SNOW ENGINEERING CO. WICHITA FALLS, TEXAS	ENGINEERING REPORT ORDER X		NUMBER 155
TITLE SERVICE LETTER #155	BY Leland Snow	CHK'D	MODEL See Below
	DATE 10/25/96		SERIAL See Below
	PAGE 1 OF 4

Vertical Fin Front Spar Fitting

MODELS:

All AT-402, AT-402A, AT-402B aircraft

VERTICAL FIN REWORK INSTRUCTIONS: (Ref. Figure 1 & 2)

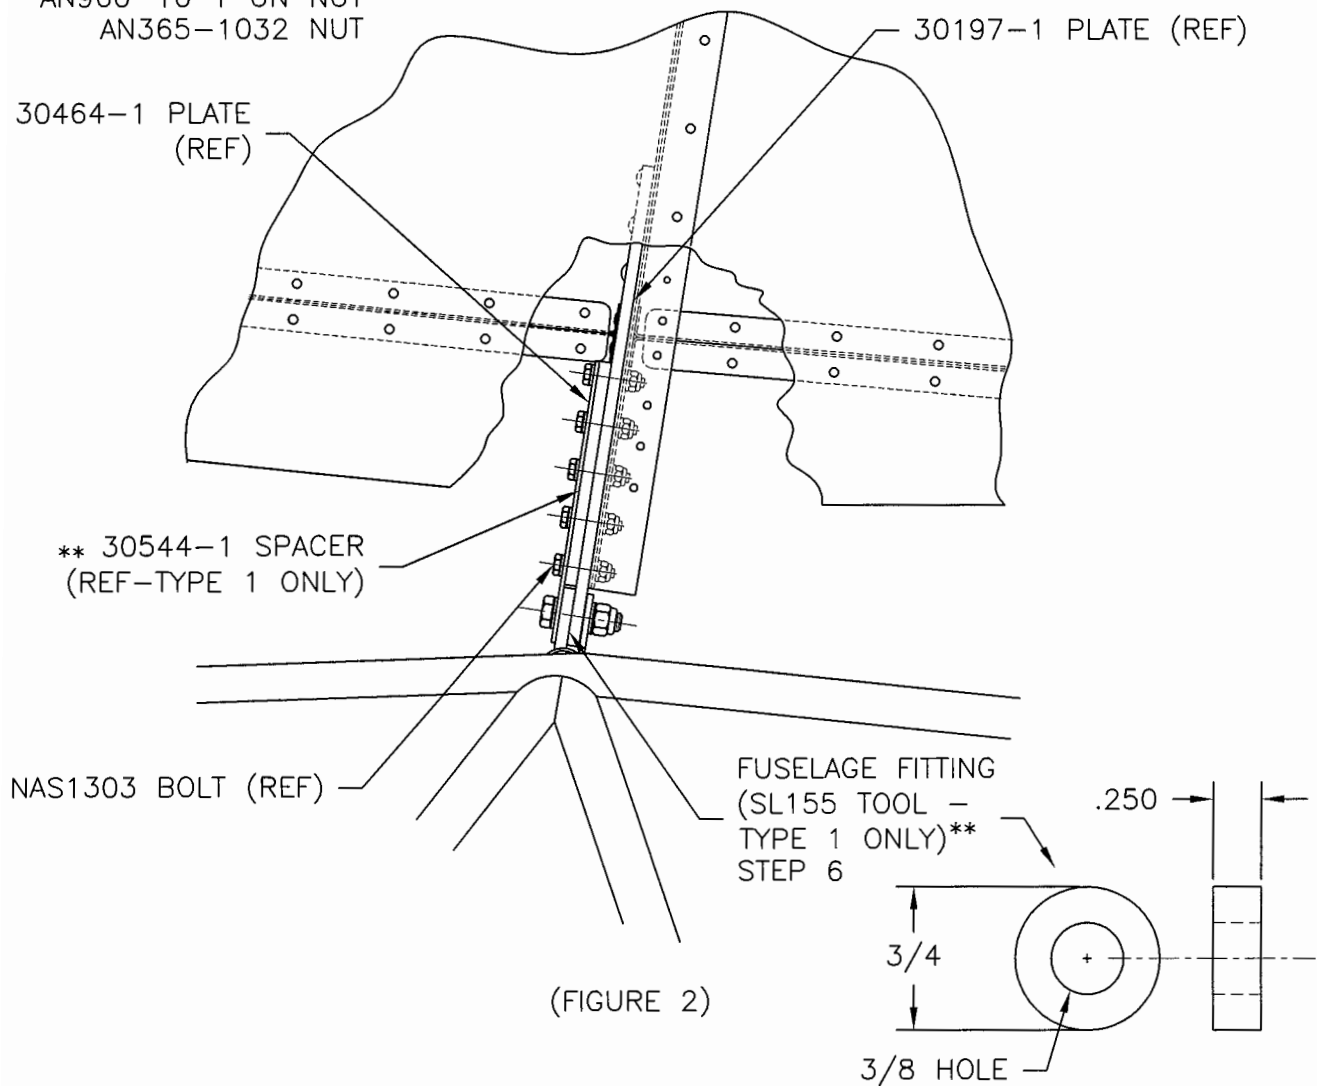
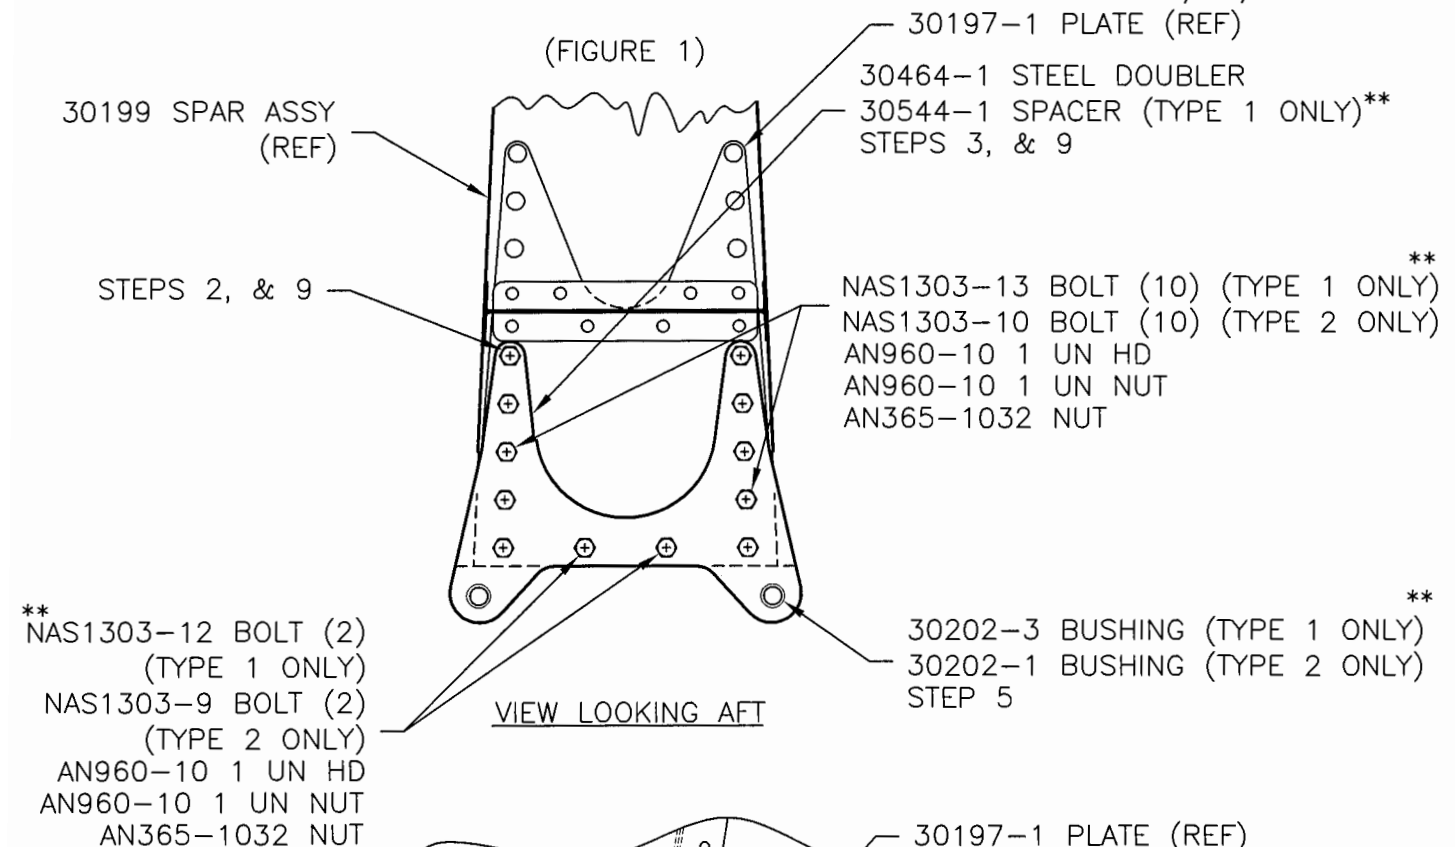
This Service Letter calls for the installation of a steel doubler to be installed on the forward side of the vertical fin front spar fitting, in a similar way as for S/L #138, except that a 1/4" spacer plate

installed to allow the fin attach fitting to straddle the 1/4" thick steel fuselage fitting that the fin attaches to.

In some instances, the steel doubler plate may already be installed flush against the aluminum fitting rather than spaced forward as shown in the Service Letter. This is an acceptable alternate and a logbook entry should be made that Service Letter #155 has been complied with.

*For the purposes of this Service Letter, we will refer to this configuration as Type 2 with the configuration described previously referred to as Type 1. View A-A on page 4 illustrates the differences in the two, with Type 2 not having the rear attach plate.

1. Remove the rudder from fin. Remove fin from aircraft.
2. Remove the lower 12 NAS1446 lockbolts that attach the front spar fitting to the front spar. Use a chisel to cut the lockbolt collars free from the lockbolts.
3. Remove excessive paint and/or sealer from the forward face of the 30197-1 plate. Prime with a suitable aircraft primer, as no bare aluminum should be permitted.
- *4. For Type 1, position the 30464-1 steel doubler and 30544-1 spacer on forward face of the 30197-1 plate.
For Type 2, position the 30464-1 steel doubler on the forward face of the 30197-1 plate.

- *5. For Type 1, insert 30202-3 bushings (2) into 30464-1 steel doubler. For Type 2, insert 30202-1 bushings (2) into 30464-1 steel doubler.
- *6. For Type 1, temporarily position the round SL155 spacer tool between the 30197-1 plate and 30464-1 steel doubler to represent fuselage fitting. Install original NAS1306 bolts and hardware thru mating parts and tighten bolts.
For Type 2, install original NAS1306 bolts and hardware thru mating parts and tighten bolts.

- 7. Back drill the 30544-1 spacer and the 30464-1 steel doubler to match the 30199 spar assy 3/16 dia. It may be necessary to use an angle drill to reach the top holes. Use care when drilling to assure good holes perpendicular to the plate.

- 8. Install the NAS1303 bolts and hardware, noting the different lengths shown in Figure 1. Torque to 60-70 inch-pounds.
- 9. Seal around doubler, spacer, and bolts with PR1422A-2 sealer to prevent moisture from entering joint.

- *10. Remove original NAS1306 bolts (and, for Type 1, SL155 tool).
- 11. Paint reworked area with a suitable paint to match the aircraft exterior color.
